**Monitoring Report
Year 5
FINAL**

Little Buffalo Creek Stream Mitigation Project

*NCDEQ-DMS Project Number: 94147
Contract Number: 2029
USACE Permit Action ID: 2014-00386
DWR Permit: 14-0129
Cabarrus County*

Subject: DRAFT Monitoring Year 5 report for the
Little Buffalo Creek Stream Mitigation Project
Yadkin River Basin – CU# 03040105– Cabarrus County
DMS Project ID No. 94147
Contract # 002029

Figure A1 – Project Components Map

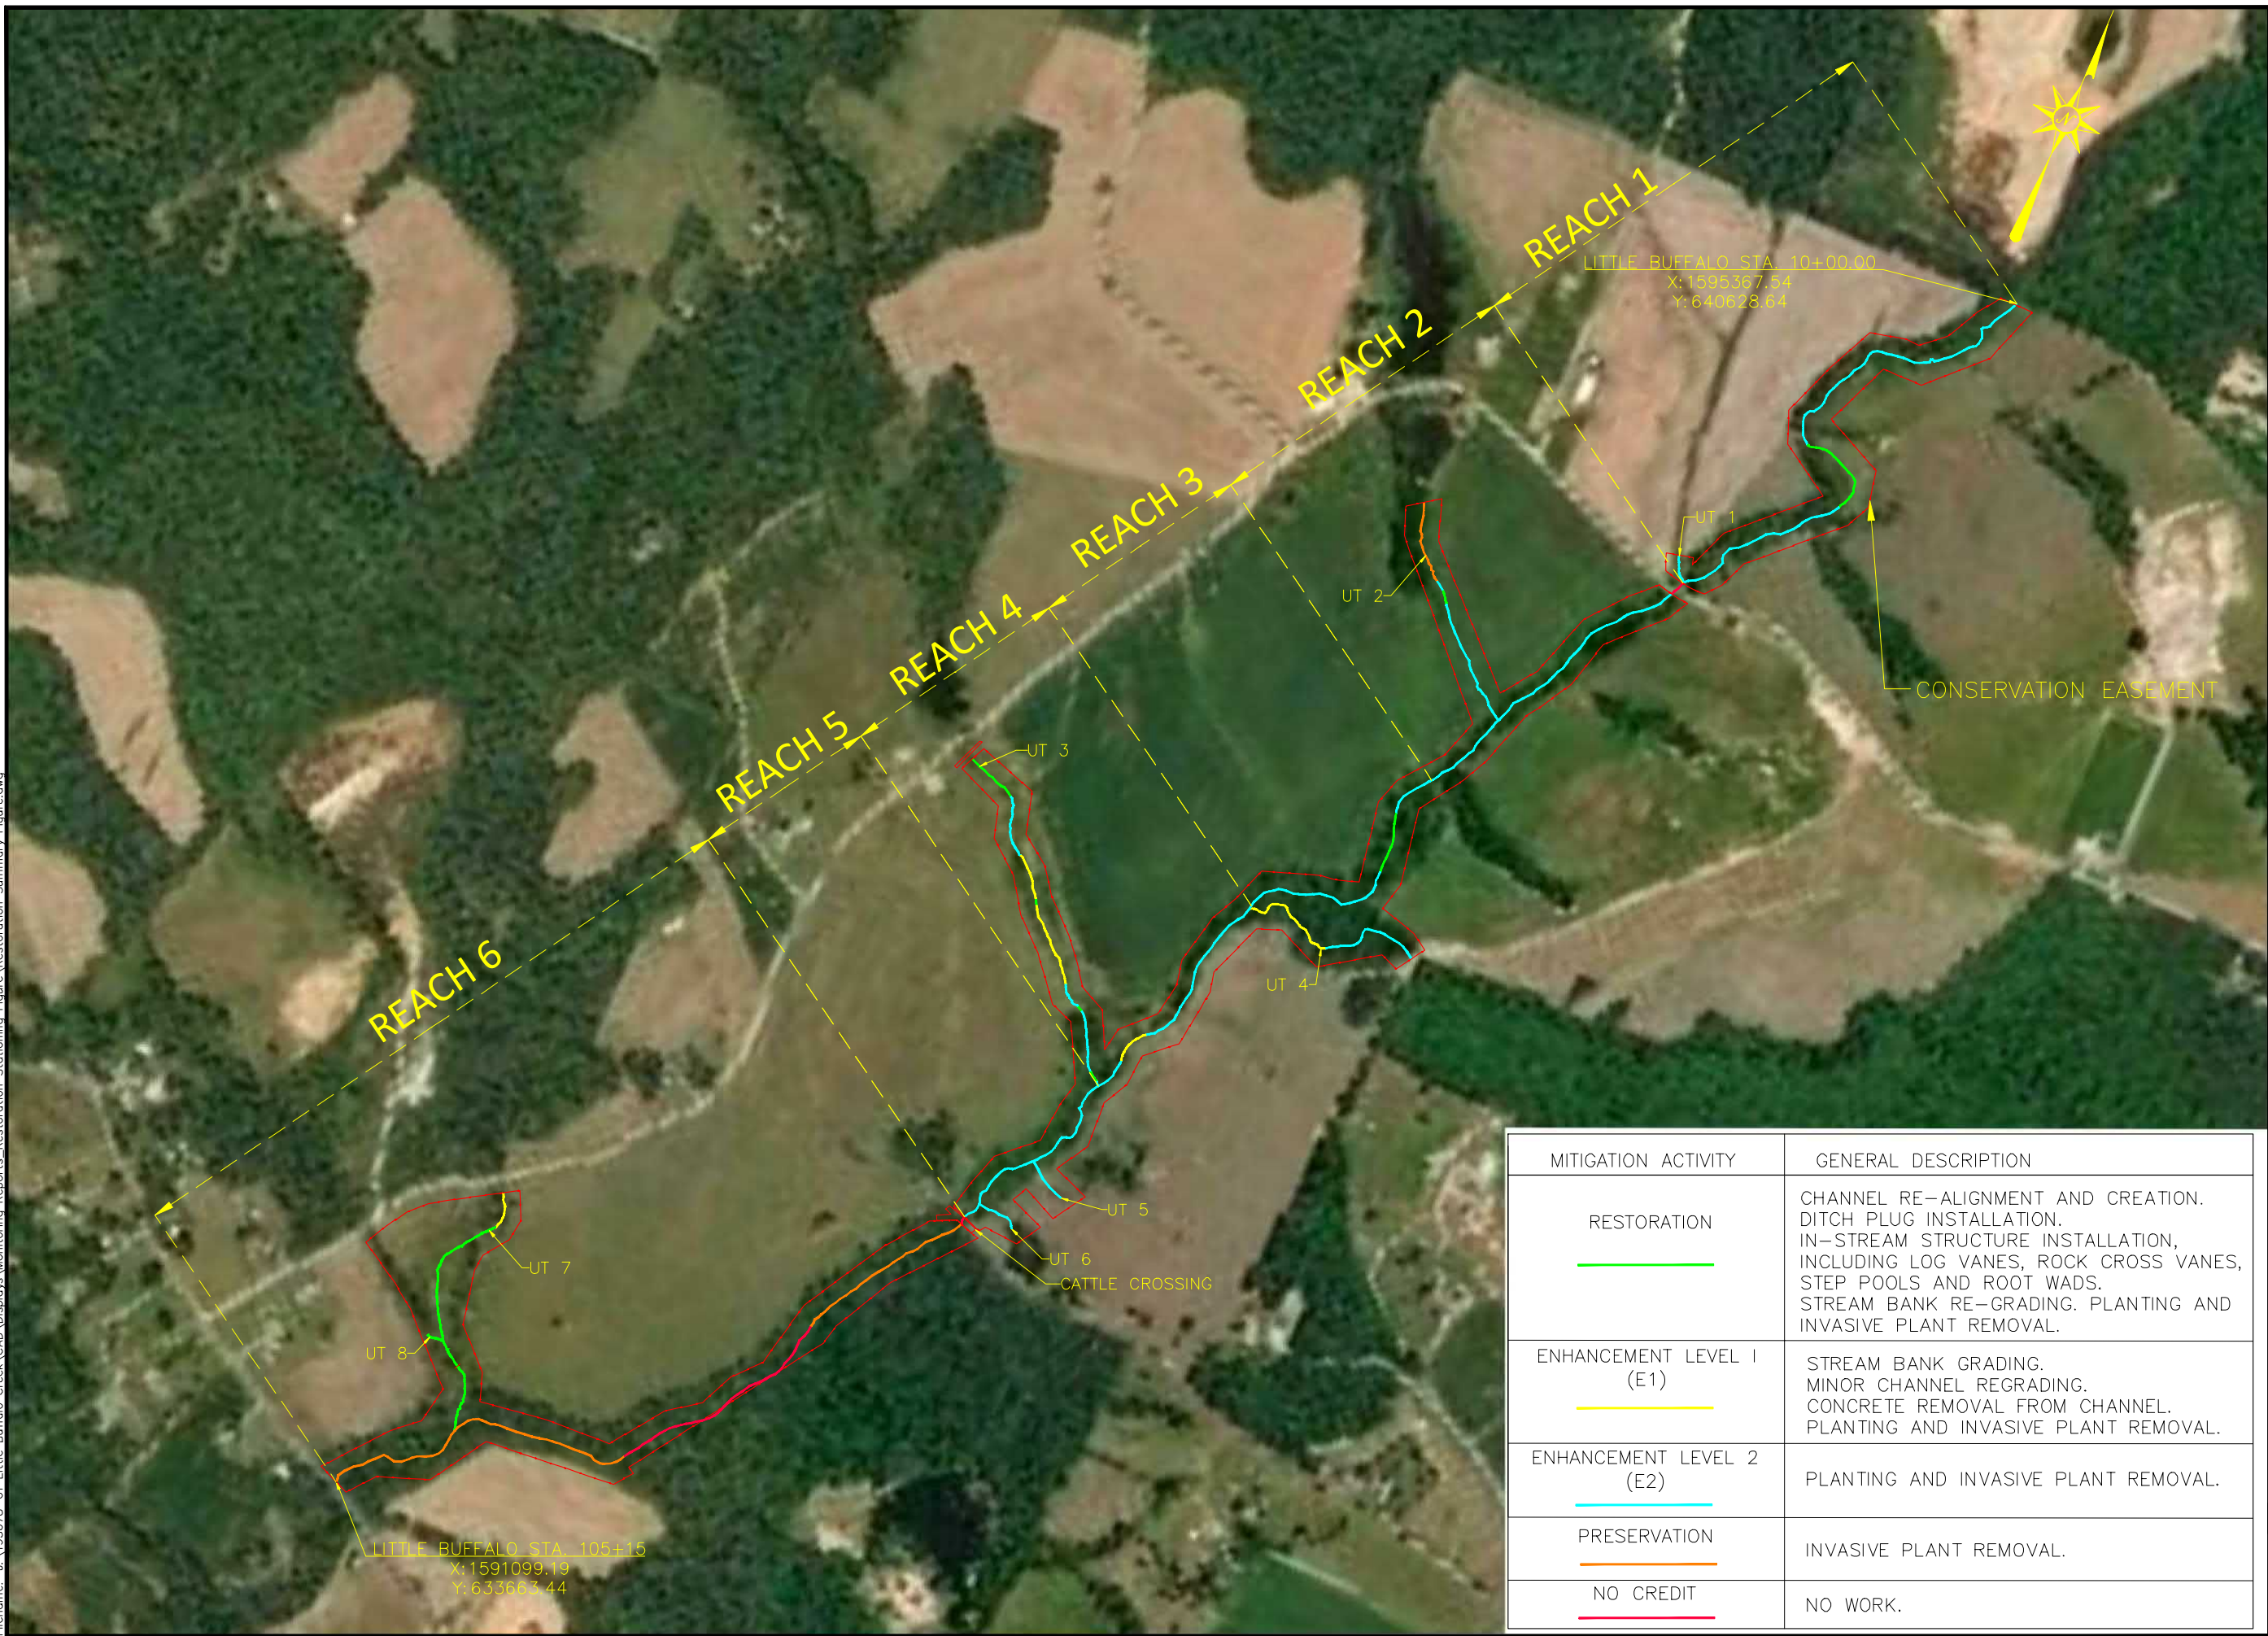
Figure A1 – Project Components Map: Recommend removing the “Proposed Easement Following Modification To Easement With DMS” callout and leader as the easement has been amended. Also; this is not applicable to the project components.

- *This callout has been removed from Figure A-1.*

Little Buffalo Creek Hydrology Monitoring - MY5
Groundwater to Surface Water Comparison, UT 2 Lower

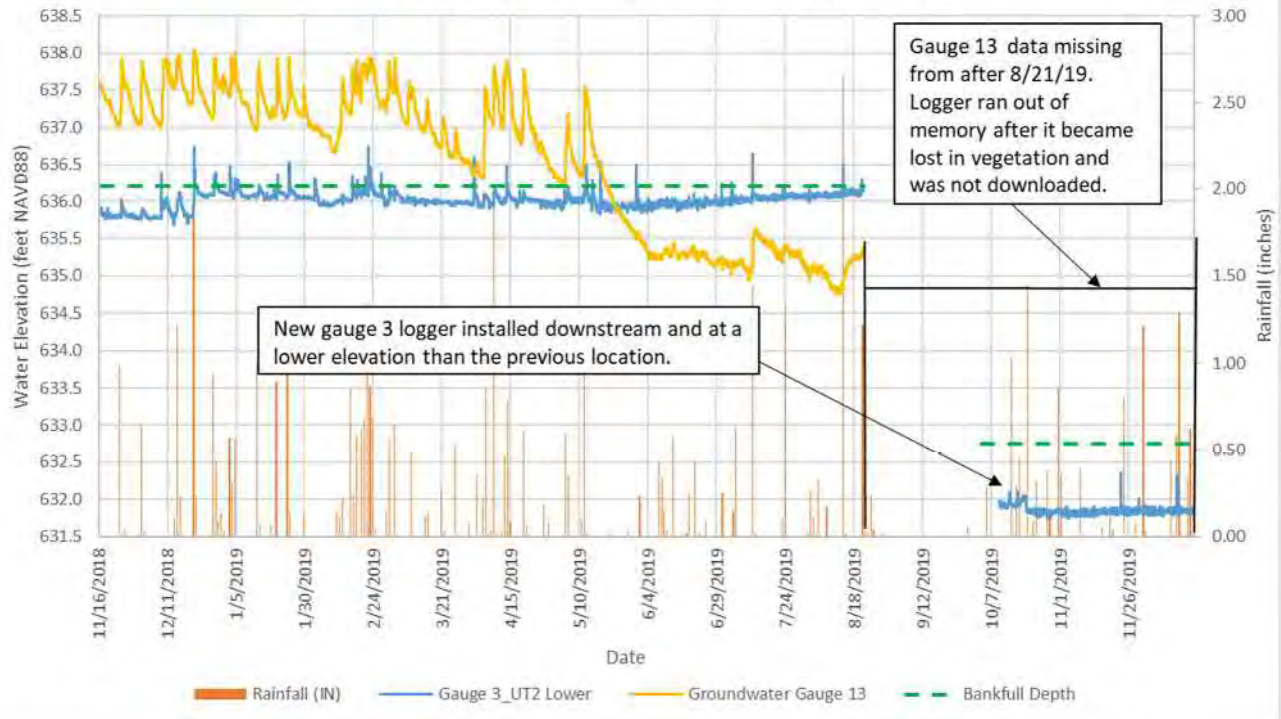
Appendix E - Figure 6c - Water Level and Rainfall Plots - Little Buffalo Creek Hydrology Monitoring Graph UT 2 Lower: Leader pointing to the missing data needs to be shifted to the correct interval of missing data.

- *The leaders shown in UT 2 Lower graph were pointing to the period of time when it was believed the instrument was buried in sediment and when a new instrument was installed. The text box for the period of missing data was intended to explain where the data were missing and did not show a leader or limits for the data gap because the data gap was bounded by notes and limits on either side. WSP recognizes this may have been confusing and has adjusted Figure 6c.*
